MFG: CHANCE RIDES, INC. NAME: ROCK & ROLL TYPE: NON-KIDDIE

#### ROK-N-ROL

#### FIELD INSPECTION POINTS

Subject:Seat Belt Latch

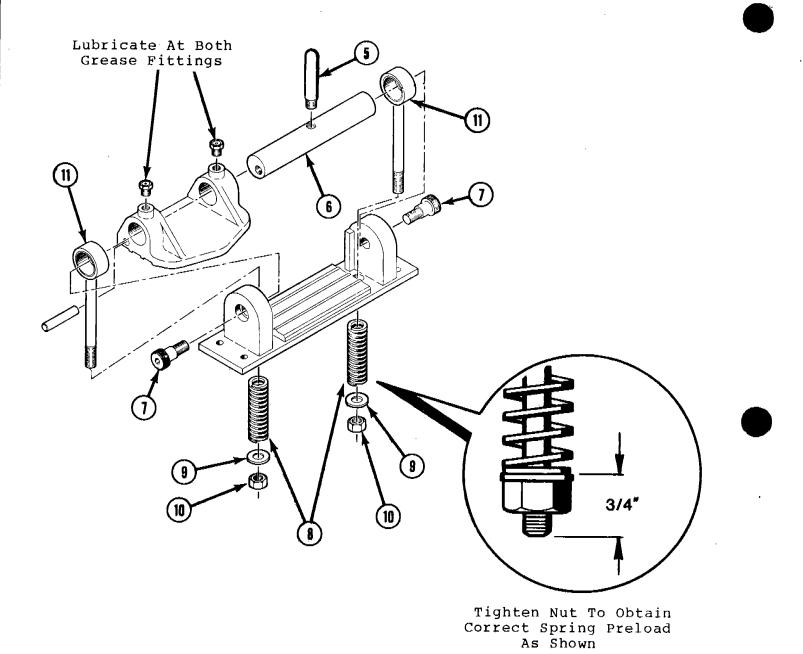
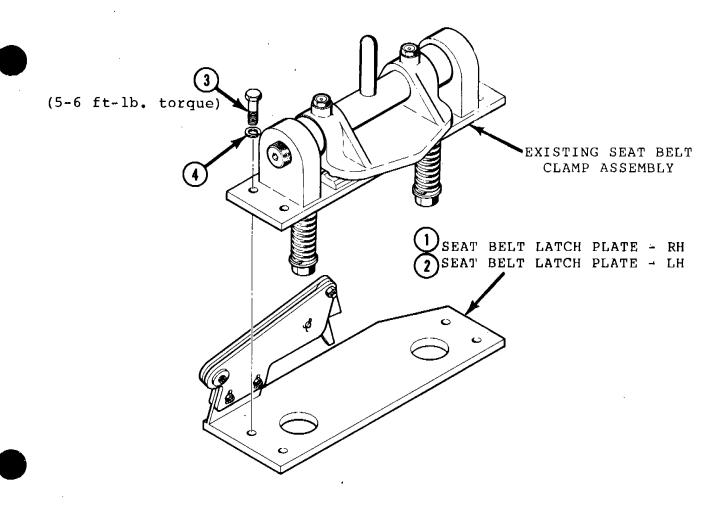
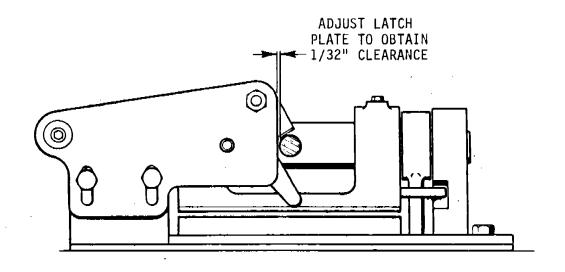
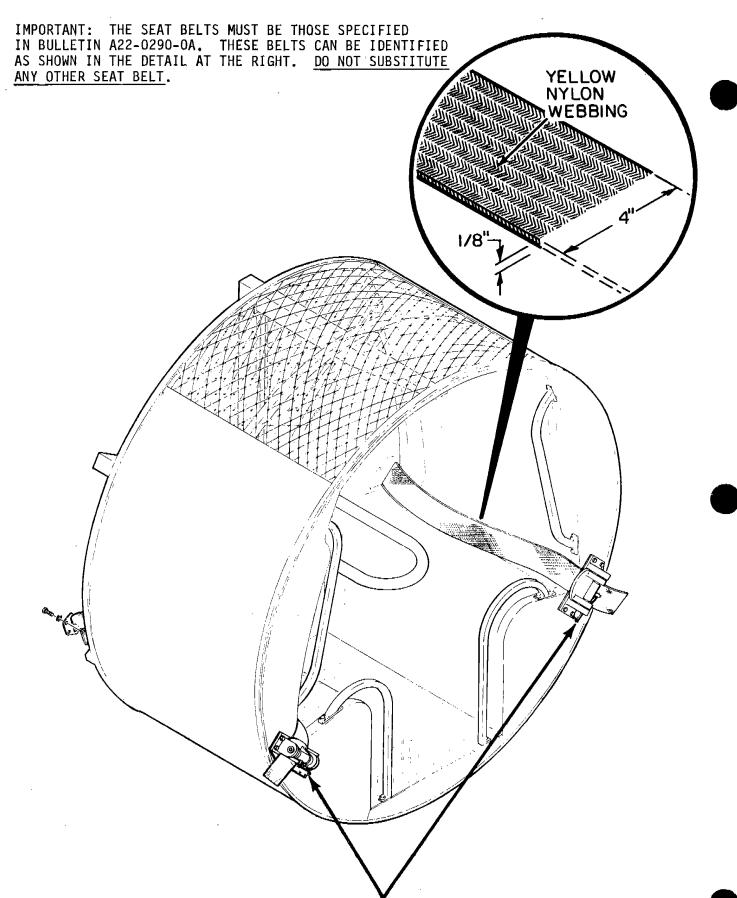
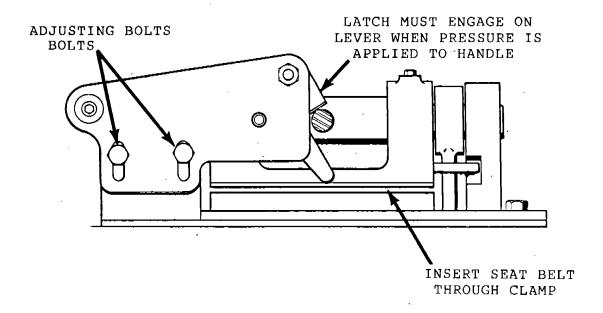
Order Kit No. K22-0320-00, Seat Belt Latch Kit to perform the modification. The kit includes the following parts:

1. Remove the seat belt clamp and discard the attaching hardware. Disassemble the seat belt clamp and inspect all the components. The handle (Item #5) and shaft (Item #6) must be replaced with the new parts provided in the kit. The new handle is larger in the threaded area for increased strength. Also replace the shoulder bolts (Item #7), eye bolts (Item #11), springs (Item #8), washers (Item #9) and locknuts (Item #10). If any other parts are worn or damaged, order replacement parts from the CHANCE CUSTOMER SERVICE DEPARTMENT.

2. Reassemble the seat belt clamp. Install the seat belt latch plate under the seat belt clamp as shown using the new bolts and lockwashers provided. Adjust the latch plate to obtain the clearance shown between the handle and the latch plate. Tighten the bolts to 5-6 ft-lb torque

IMPORTANT: The seat belt latch plates are provided as right hand and left hand parts. Install them as shown so that the latch lever is in the lowest position on the seat.

3. Adjust the latch plate as described below:

- Loosen adjusting bolts.
- Insert the seat belt through the seat belt clamp and apply the clamp
- Adjust the latch so that it engages on the clamp lever when pressure is applied to the clamp handle.
- Tighten the adjusting bolts to 5-6 ft-lb. torque.
- 4. Repeat Steps #1, #2 and #3 for all remaining seats.

# INSPECTION PROCEDURE

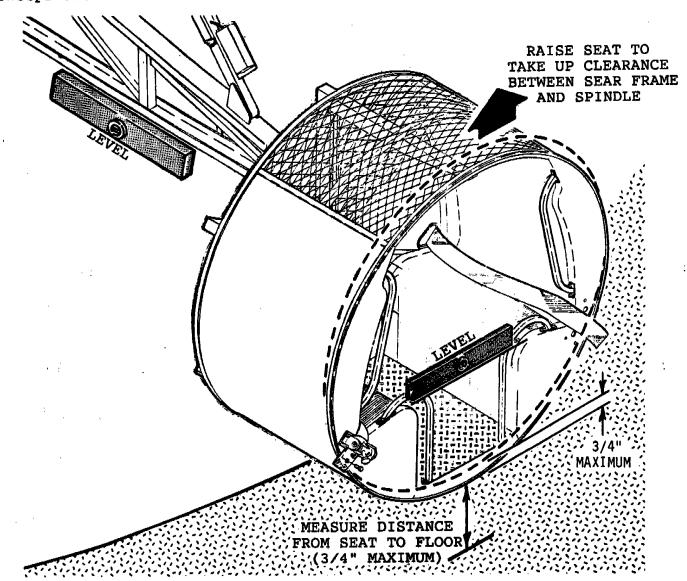
Check each seat spindle for excessive wear using the following procedure.

1. The ride must be set up and level, as for normal operation. The sweeps and each seat must be level.

- 2. Measure the distance from the floor to the bottom of the seat as shown, and record this measurement.
- 3. Raise the seat as shown, taking up the clearance between the seat frame and the spindle. Measure and record the distance between the same spot on the floor and the bottome of the seat.
- 4. Subtract the measurement in Step 3 from the measurement in Step 4. If the difference exceeds 3/4", excessive wear is indicated.
- 5. Repeat Steps #2, #3 and #4 on all remaining seats. IF EXCESSIVE WEAR IS INDICATED ON ANY SEAT, ALL SEAT SPINDLES AND SEAT FRAMES MUST BE REPAIRED AS DESCRIBED IN THIS BULLETIN.

# INSTALLATION INSTRUCTIONS

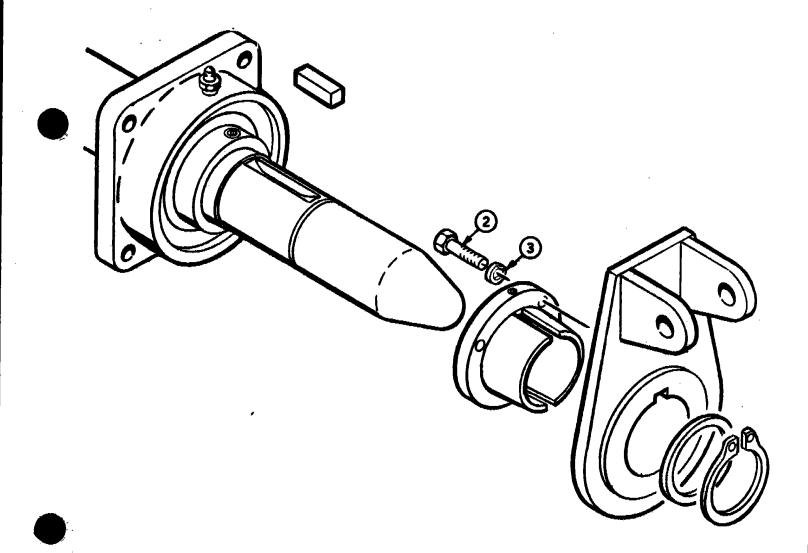
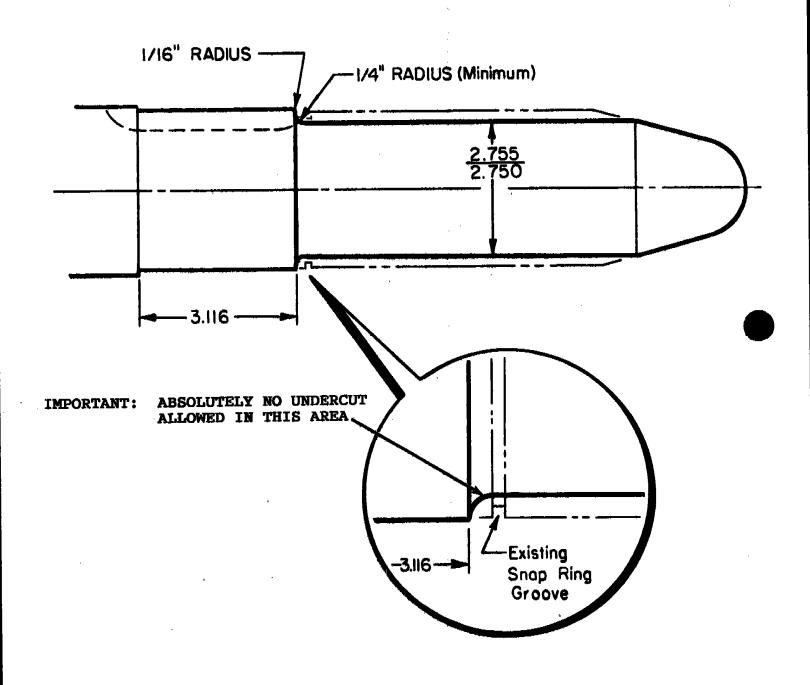
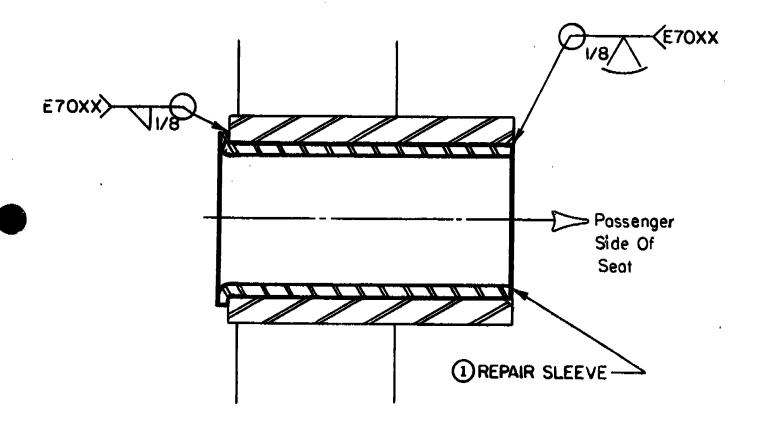
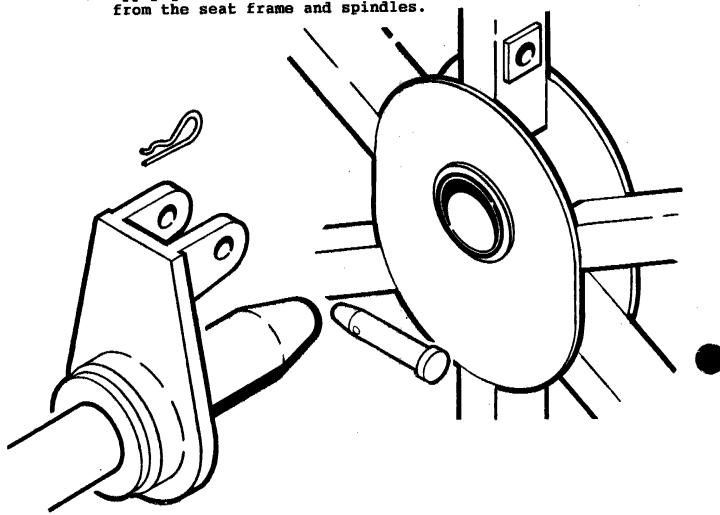
- Remove the seats from the sweeps.
- 2. Remove the looping shaft from the sweep and disassemble it as shown below.

3. Turn the seat spindles to the dimensions shown in the following drawing. If seat spindle is worn beyond the dimensions shown, contact the CHANCE CUSTOMER SERVICE DEPARTMENT.

- 4. Reassemble the looping shafts, omitting the washers and snap rings (Refer to 373-150-001). Use the new grade 8 bolts and hardened washers (Items #2 and #3) provided in the kit. Tighten to 27 33 ft-lb.
  - 5. Install and weld a repair sleeve into each car frame as shown in the following drawing.

6. Liberally apply No. 2 lithium base grease to the spindles. Reinstall all seats on spindles, using the pin and hairpin through the seat hub and sweep frame (Refer to Drawing No. 373-150-001).

NOTE: If the repair sleeve is too tight on the spindle, sand or hone the inside diameter of the repair sleeve. DO NOT MACHINE THE SHAFT FURTHER.

Subject: Seat Belt System

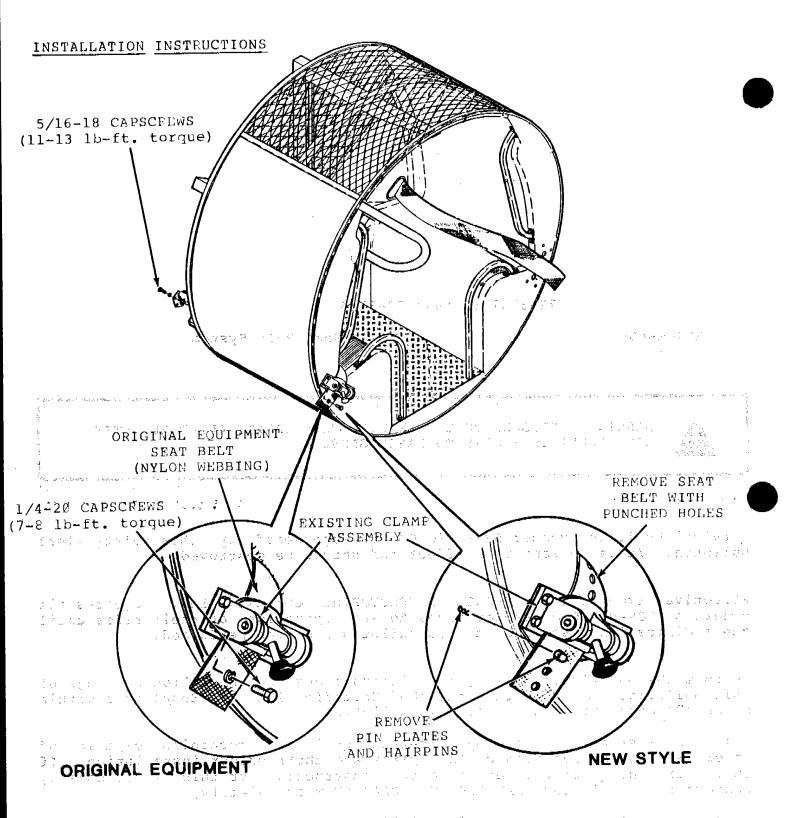
Effective immediately, CHANCE MANUFACTURING COMPANY, INC. requires all owners of ROK-N-EOL amusement rides to stop operation of their rides until the modification described in this bulletin has been performed.

- l. Remove the new style pin plates, hairpins and seat belts from all the seats. These seat belts have punched holes for positive locking over the pin plate, in addition to the clamp assembly.
- 2. Install the original equipment seat belts (part number 322-05435). These seat belts are made of nylon webbing without holes and retained by the clamp assembly.

Figure 3. Air Chamber Modification

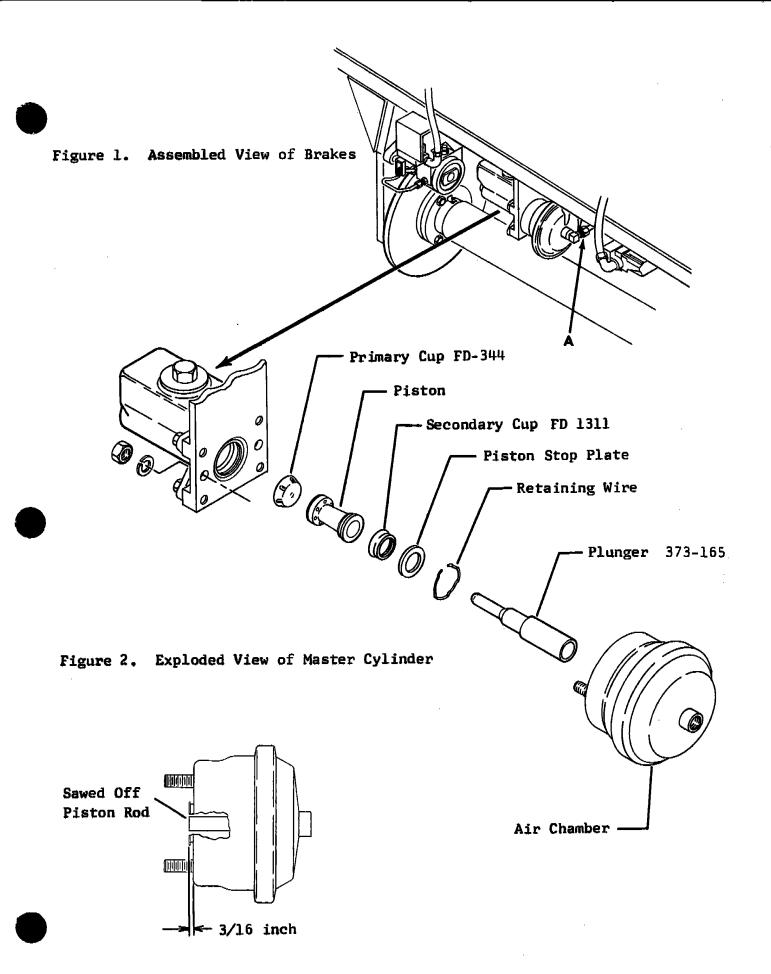
This kit is to correct the problem of leaking Master Cylinders. The Air Chambers are overstroking the cylinders, causing the cups inside of cylinders to be damaged. This allows brake fluid to leak by the cups and out the end of the cylinder. In addition, the leaking cylinders will only hold pressure for a short time, resulting in the loss of brakes.

- Disconnect the air supply tube (A) from the Air Chamber, and remove the nuts that secure chamber to sweep.
- 2. Remove the Air Chamber and saw off the plunger or piston rod so that 3/16 inch protrudes above the face of the chamber or until piston rod is flush with the brass ring that secures the diaphram. See Figure 3.
